## **Landscape Comments on Planning Application**

**October 2021**

**Ribble Valley Borough Council Planning Application Reference: 3/2021/0660**

### **Haweswater Aqueduct Resilience Project - Bowland Section**

## **22) Newton in Bowland Compound Environment Masterplan Drawings 1 – 4**

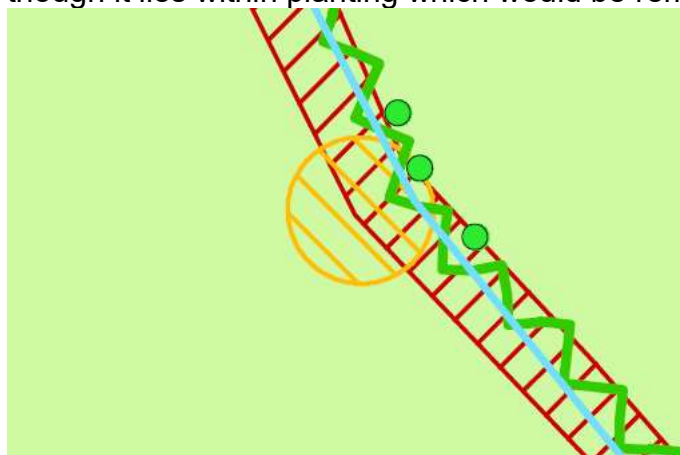
The proposals regarding existing vegetation do not differentiate between trees or shrubs. Everything is lumped together under the words, *"Existing vegetation."* It is possible to determine what the various existing vegetation 'shapes' are with reference to the tree survey, but for ease of use, the different types of vegetation should have been clearly labelled on the environmental masterplans.

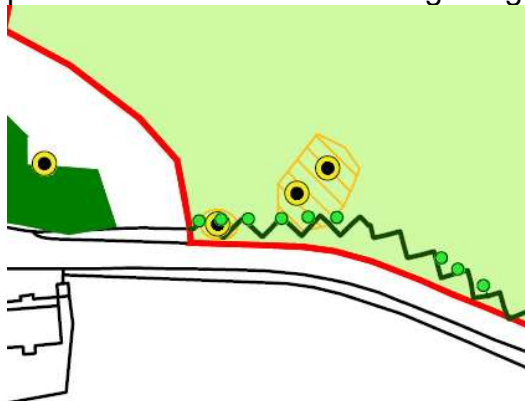
At the location in the screenshot below, the vegetation adjacent to the hedgerow is identified as being at risk even though the hedgerow itself is down to be retained. As the two are so close together I cannot understand why only some of the vegetation is at risk of removal. Their location on the edge of the compound site also suggests that removal is

unnecessary. Removal of the vegetation would likely have adverse impacts on the retained hedgerow – root compaction, root loss, etc. New tree planting is also shown within the root protection areas of the existing hedgerow.

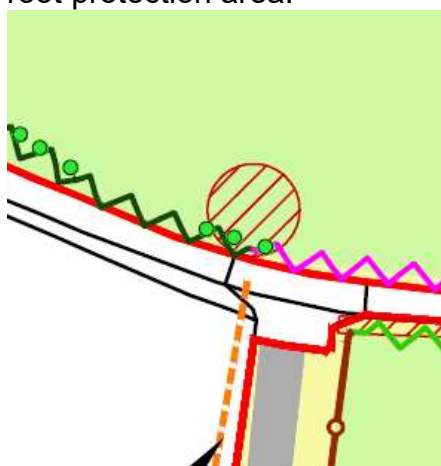
At various locations – see an example in the screenshot below – the applicant proposes to plant trees within the root protection areas of existing vegetation (which is presumably trees, shrubs and hedgerows - the drawings do not clearly mark the different types). Generally, it is advisable to avoid undertaking any works within root protection areas especially if they involve excavation.

### **23) Proposed Newton in Bowland compound construction phase drawing sheets 1 - 2**

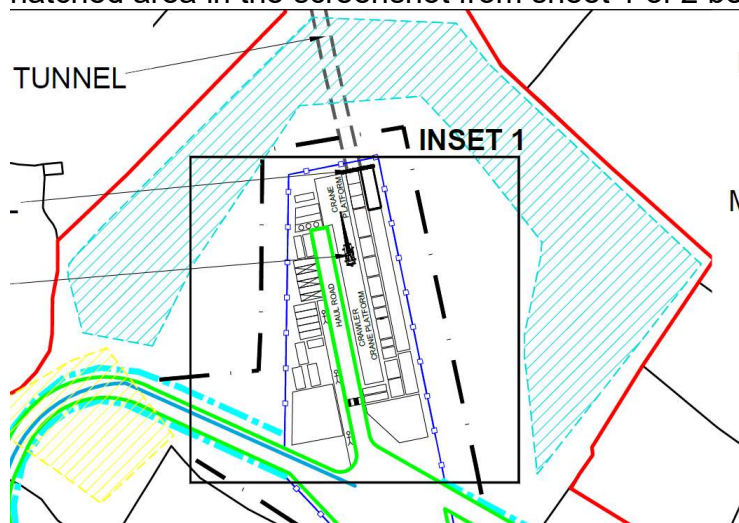
It is worth noting that unlike the proposals for the Lower Houses compound no 'Acoustic screening' for use during what the applicant referred to as *"noisy works within overall site extents"* are shown on the 2 drawings. Presumably this is because no acoustic screening is proposed which if so, is surprising given the scale of the works within the main compound and their similarity.

## **26) Compound Sections - Newton in Bowland Compound Drawing**

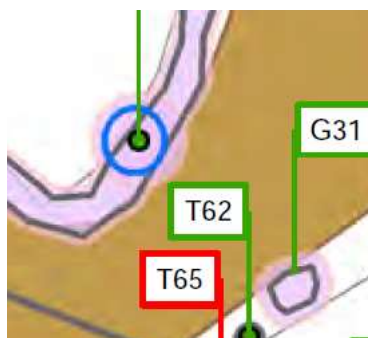
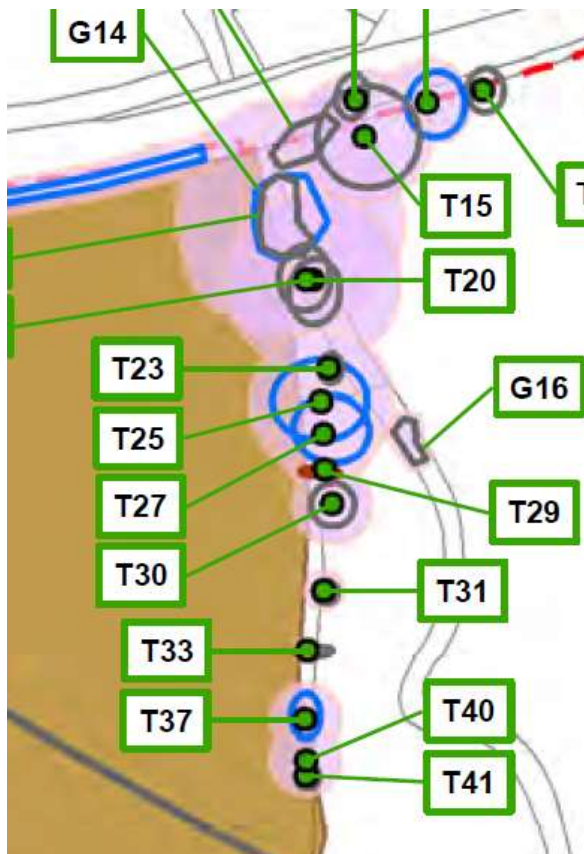
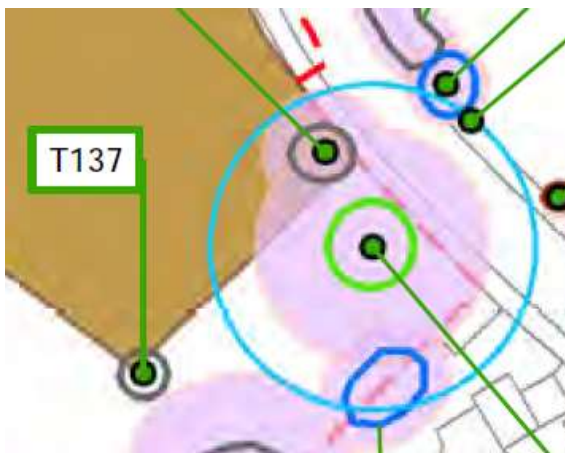
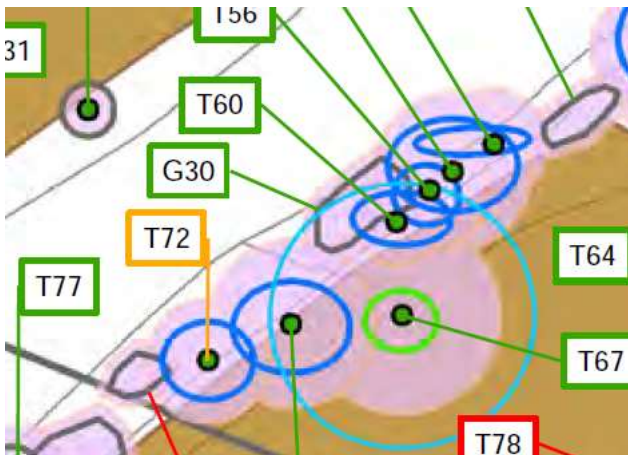
Only 2 sections have been provided which is not enough to give a full picture of the extent of the Newton in Bowland compound works.

Due to its 45m boom height, the crane would be widely visible. To limit visual impacts, it is recommended that the crane's boom is lowered when not in use.

## **27) Ribble crossing and haul road Environmental Masterplan (EMP) Drawings 1 - 2**

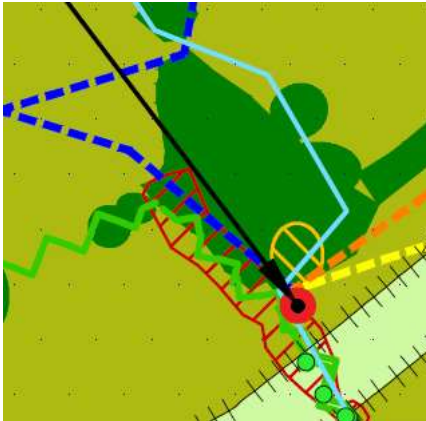
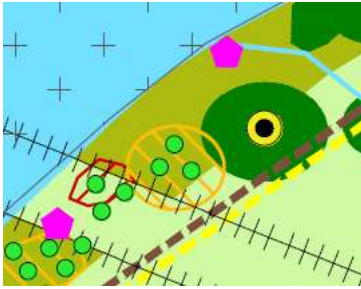
The proposed location of some of the scheme elements appears not to have been informed by the information provided in the applicant's ***Tree Constraints and Assessment Plans 1 – 4***. There are locations where temporary works would be undertaken within the root protection areas of existing trees intended for retention. Examples of this are shown in the screenshots below taken from the ***Tree Constraints and Assessment Plans 1 – 4***:

Construction lay down areas:

Temporary access road:
